**ZONING AMENDMENT, SUBDIVISION
& SIDEWALK WAIVER STAFF REPORT**

C & G Boatworks

Davenport Properties Subdivision, Unit Two

414 Cochrane Causeway
(East side of Cochrane Causeway, ½ mile+ North of the
Bankhead Tunnel)

SITE PLAN

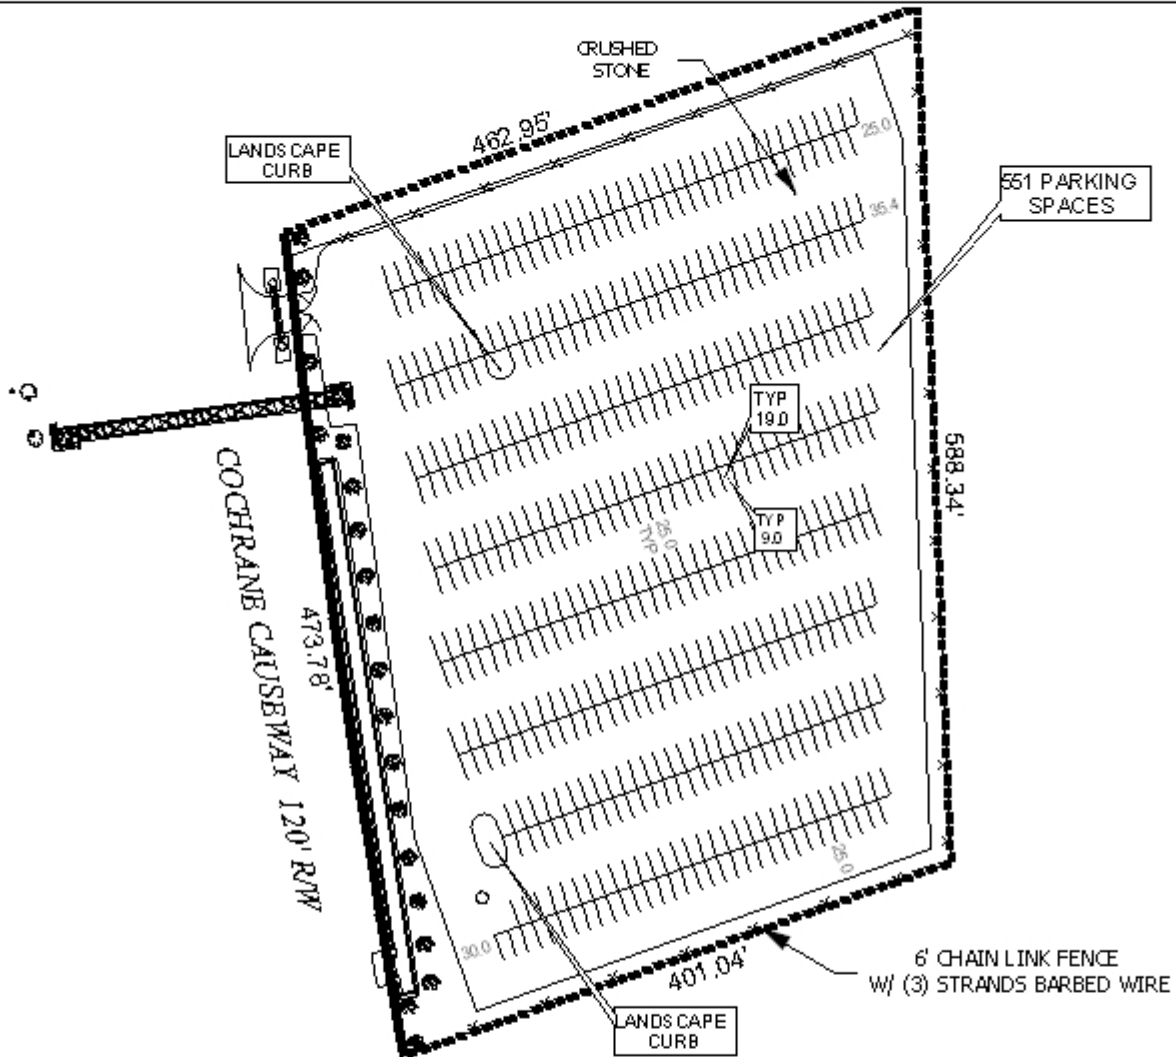
There are no issues relating to the site plan submitted, the applicant has addressed all points in determining the design and circulation of the parking area. However, the site will provide approximately 557 spaces for vehicles; therefore, the site plan should be revised to comply with Section 64-4.E.3.b. The site plan submitted does not illustrate the minimum landscaping requirements; however, the site does meet the tree requirements of the Ordinance.

Access management is a concern due to the site fronting on a major street. The site plan illustrates only one curb cut; which may be inappropriate for the amount of vehicular traffic entering/exiting the site, therefore, the redevelopment of the site to illustrate two curb-cuts, with the size, design and location to be approved by Traffic Engineering and conform to AASHTO standards.

The 25-foot minimum building setback line, required in Section V.D.9., is not shown for the subdivision, but would be required on the Final Plat, if approved.

- 1) placement of a note on the final plat stating that the development be limited to two curb-cut, with the size, design and location to be approved by Traffic Engineering and conform to AASHTO standards.
- 2) depiction of the 25-foot minimum building setback line from all street frontages (including Interstate 10), as required by Section V.D.9. of the Subdivision Regulations;
- 3) the labeling of the lot with its size in square feet, or placement of a table on the plat with the same information; and
- 4) full compliance with all other municipal codes and ordinances.

CROSS SECTION DETAIL

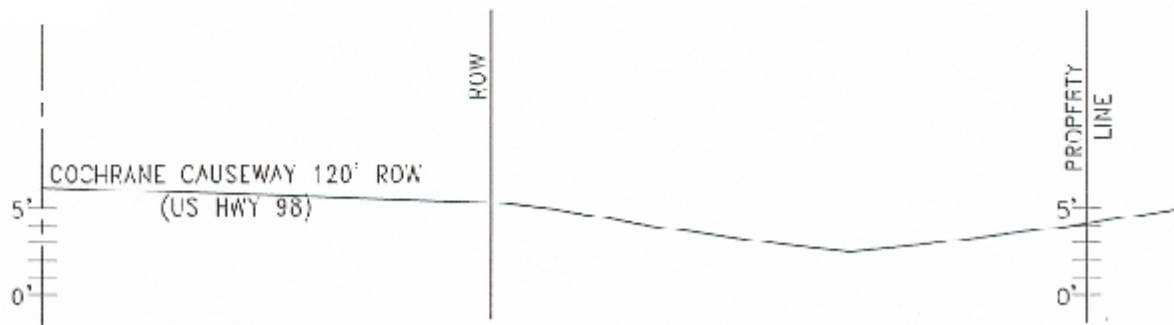
Based on topographic information provided by the applicant, it does not appear that City standard sidewalk is constructible at this location.

As Engineering Department states there are significant topographic constraints (roadside ditch) that would preclude the construction of a sidewalk at this location.

Sidewalk Waiver: Based upon the preceding, this application for waiver of the sidewalk along Cochrane Causeway is recommended for approval.
